MIL-PRF-19500/556L
w/AMENDMENT 3
2 July 2026
SUPERSEDING
MIL-PRF-19500/556L
w/AMENDMENT 2
13 April 2021

TRANSISTOR, FIELD EFFECT, N-CHANNEL, SILICON, TYPES 2N6782, 2N6784, AND 2N6786, JAN, JANTX, JANTXV, JANS, JANHC, AND JANKC

* FIGURE 5. JANHCC and JANKCC (C-version) die dimensions for 2N6782, 2N6784.

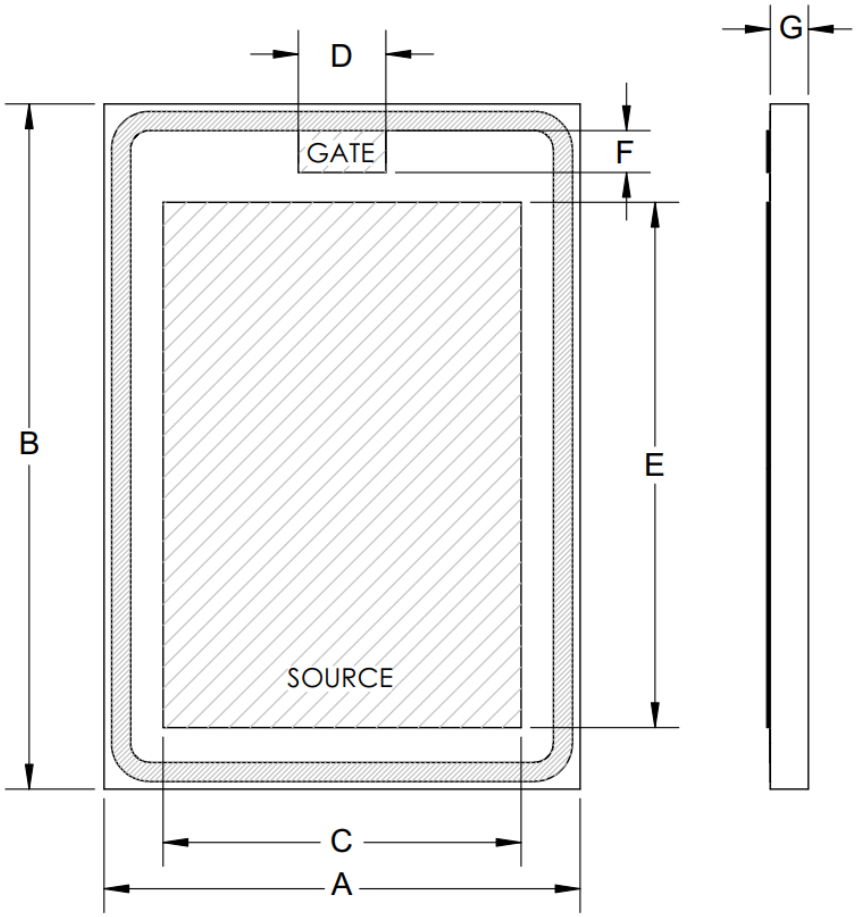
* 1.2 Package outlines. The device package outlines are as follows: TO-205AF in accordance with figure 1 and leadless chip carrier (LCC) in accordance with figure 2 for all encapsulated device types. See figures 3, 4, and 5 for all unencapsulated devices.

* 1.6 Die identifiers for unencapsulated devices (manufacturers and critical interface identifiers). The manufacturer die identifiers that are applicable for this specification sheet are "A", "B", and "C" (see figures 3, 4, and 5).

Ltr	Dimensions 2N6782, 2N6784			
	Inches		Millimeters	
	Min	Max	Min	Max
A	0.120	0.130	3.05	3.30
B	0.175	0.185	4.44	4.70
C	0.089	0.099	2.26	2.51
D	0.020	0.026	0.51	0.66
E	0.133	0.143	3.38	3.63
F	0.009	0.013	0.23	0.33
G	0.012	0.016	0.30	0.41

NOTES:
1. Dimensions are in inches. Millimeters are given for general information only.
2. Die thickness = .014 ±.003 inch (0.36 ±0.07 mm).
3. Back metal: Titanium 1.15KÅ, Nickel 2KÅ, and Silver 8KÅ. Nominal.
4. Top metal: Al 40KÅ. Nominal.
5. Back contact: Drain.
